ON-SITE SEWAGE DISPOSAL SYSTEM HOWARD COUNTY HEALTH DEPARTMENT BUREAU OF ENVIRONMENTAL HEALTH

SUBDIVISION: Monticello LOT NUMBER: 12

ADDRESS: 1750 Oakdale Drive PROPERTY OWNER: D. R. Horton, Inc.

SEPTIC SPECIFICATIONS WORKSHEET

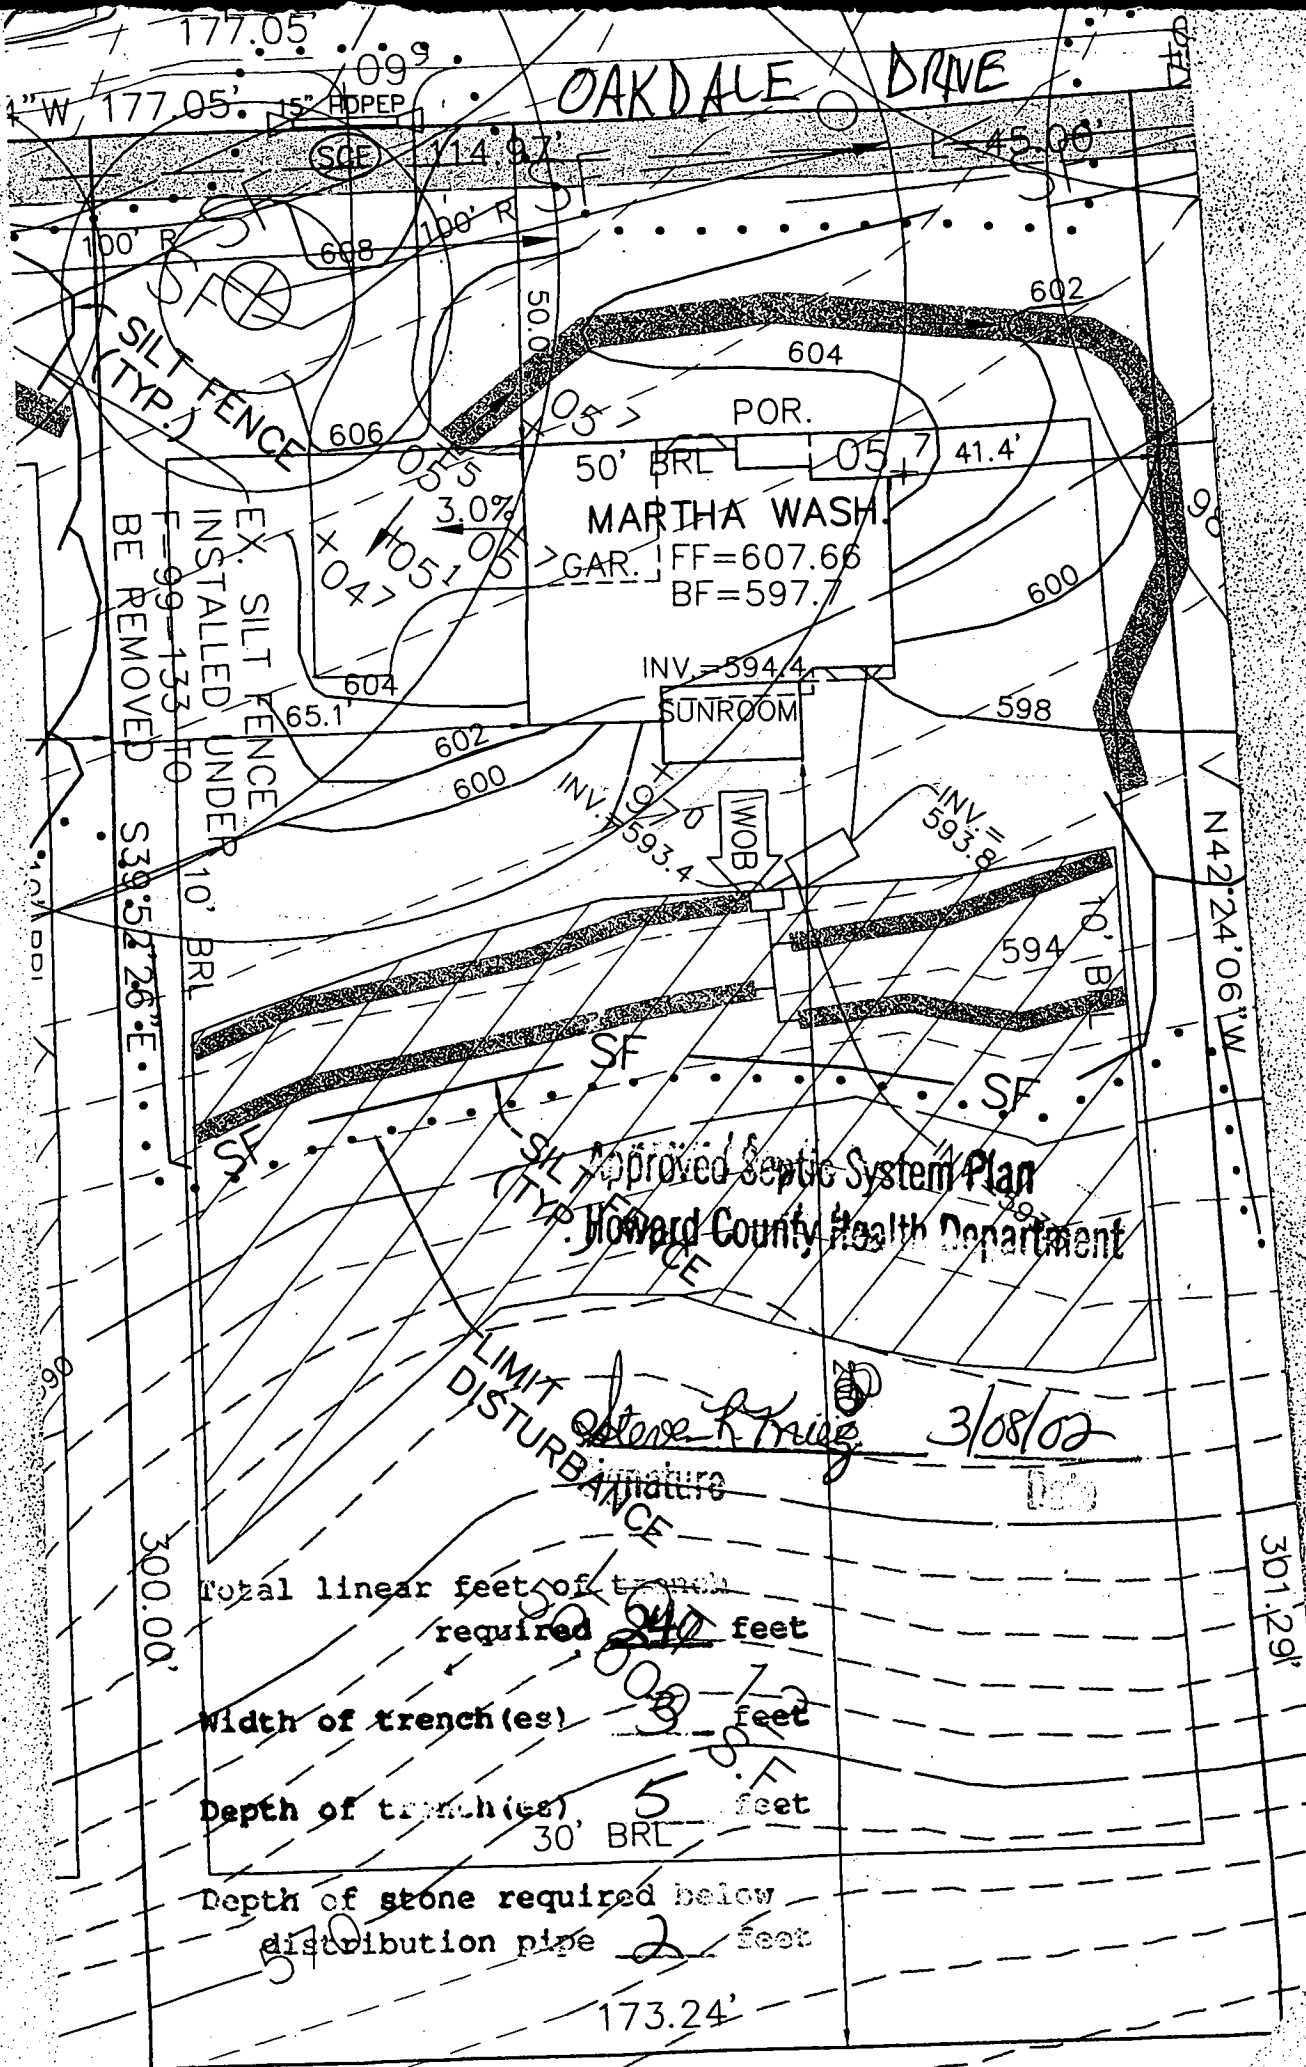
PRE-CONSTRUCTION 7/12/02 lot staked. OK to cover DB. in middle w/ (14) 60's (SO)

INSTALLATION 7/16/02 Tank set. OK to cover 7/19/02 3 trenches finished OK to cover. 4th trench contr. ran out of stone (SO)

7/22/02 4th trench finished OK to cover (SO)

Approved Septic System Plan
Howard County Health Department

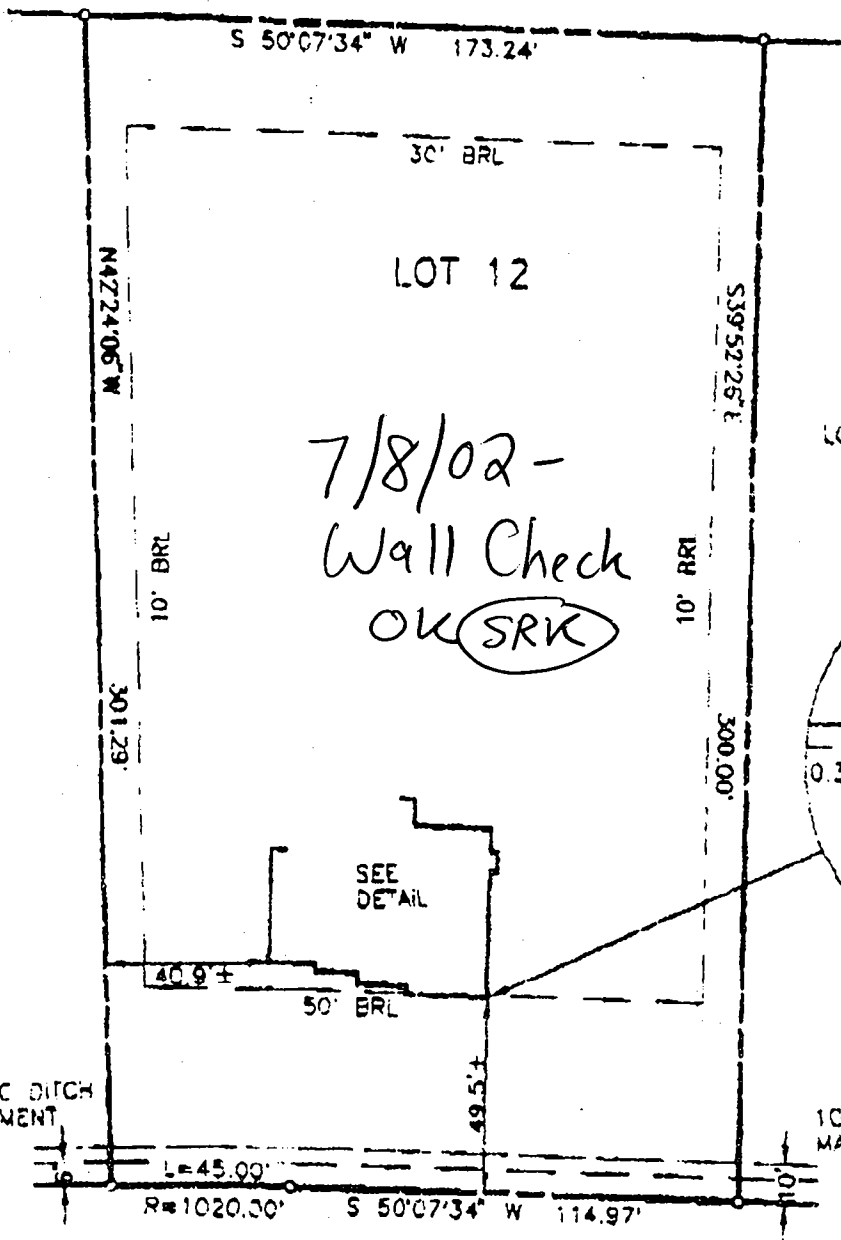
Total linear feet of trench required 247 feet
 Width of trench(es) 3 feet
 Depth of trench(es) 5 feet
 Depth of stone required below distribution pipe 2 feet

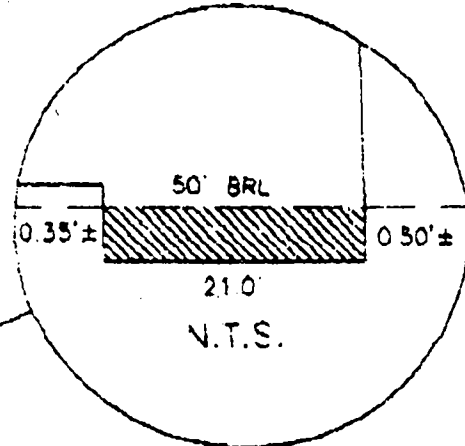
7/8/02 -
Wall Check
OK (SRK)
